# Access Compliance Report

### (Curb Ramps)

Intersection ID: 10020375	Main Street: BALLANTYNE CORPORATE PL	Cross Street: N/A	Location: NW
ADA ID: 159616721D15	Ramp Type: BlendTrans2	Initial Pass/Fail: Fail	Overall Compliance: No
		Severity Score: 1.25	
Codes/Mitigation Info/Possible Solution		Field Measurements/Component Compliance

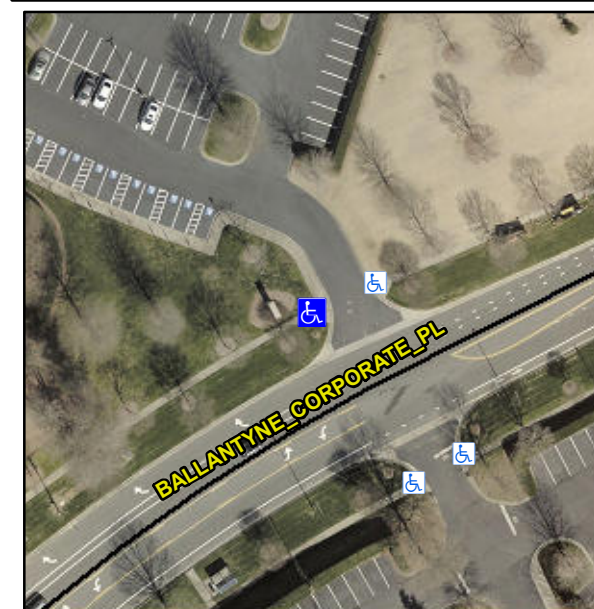
**R304.5.3**

Compliance	Description	Data	Compliance	Description	Data
N/A	Ramp Length (in)	108.0	Yes	BlendTrans Slope (%)	0.6
Yes	Ramp Width (in)	48.0	No	BlendTrans XSlope (%)	4.9
N/A	Flare Type LT	N/A	N/A	Flare Type RT	N/A
N/A	Flare Slope LT (%)	N/A	N/A	Flare Slope RT (%)	N/A
N/A	Flare Traversable LT?	N/A	N/A	Flare Traversable RT?	N/A
N/A	Landing Length (in)	N/A	N/A	DWS Provided?	N/A
N/A	Landing Width (in)	N/A	N/A	DWS Contrast?	N/A
N/A	Landing Slope (%)	N/A	N/A	DWS Length (in)	N/A
N/A	Landing X Slope (%)	N/A	N/A	DWS Full Width?	N/A
N/A	Landing Curb? (Y/N)	N/A	N/A	DWS Offset (in)	N/A
N/A	Shared Landing?	N/A			
N/A	Gutter Ponding?	N/A	N/A	Gutter Slope (%)	N/A
N/A	Gutter Lip Ht (in)	N/A	N/A	Gutter X Slope (%)	N/A
N/A	Painted X Walk1?	No	N/A	Painted X Walk2?	N/A
	X Walk 1 Direction	To NE		X Walk 2 Direction	N/A
	X Walk 1 Width (in)	N/A		X Walk 2 Width (in)	N/A
	X Walk 1 Slope (%)	2.9		X Walk 2 Slope (%)	N/A
	X Walk 1 X Slope (%)	0.7		X Walk 2 X Slope (%)	N/A

**Remove & Replace Curb Ramp With Two New Directional Ramps or Equivalent.**
